THE RISE

SB 35 Development – Modification Request Project Description

March 24, 2022

Figure 1: Project Site Diagram

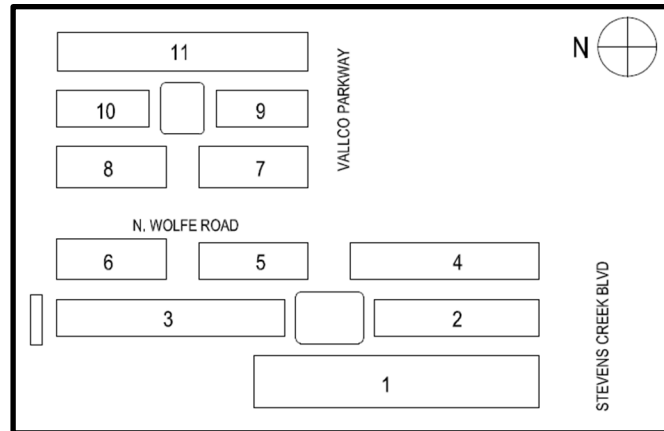
As described above, the overall Town Center-based land use program remains the same. Each of the eleven major blocks comprising the Project site retains the general mix of land uses as set forth in the SB 35 Approval (i.e., Block 1 remains dedicated to residential and retail uses; Block 6 remains dedicated to office use, etc.). For reference, [Figure 1: Project Site Diagram](#) provides a simplified overview of the Project site layout and block numbering.

In certain areas, the specific locations of land uses have shifted within particular blocks. For example, within Blocks 4 and 5, townhome units have been replaced with street fronting retail uses (shifting residential area to, and intensifying residential use at, the upper levels, including those above the green roof). Retail has also been added in the plazas: while the East Plaza's pavilion was removed, two new pavilions were added to the West Plaza. Furthermore, in response to community concern over the private residential amenity enclosed within the bridge over Wolfe Road, the modification request includes the removal of this structure and replaces it with a turfed play field providing a new area of open space and enhancing connectivity across the green roof. The displaced residential amenity has been distributed to the various residential blocks in the project, which also serves to improve access thereto by residents.
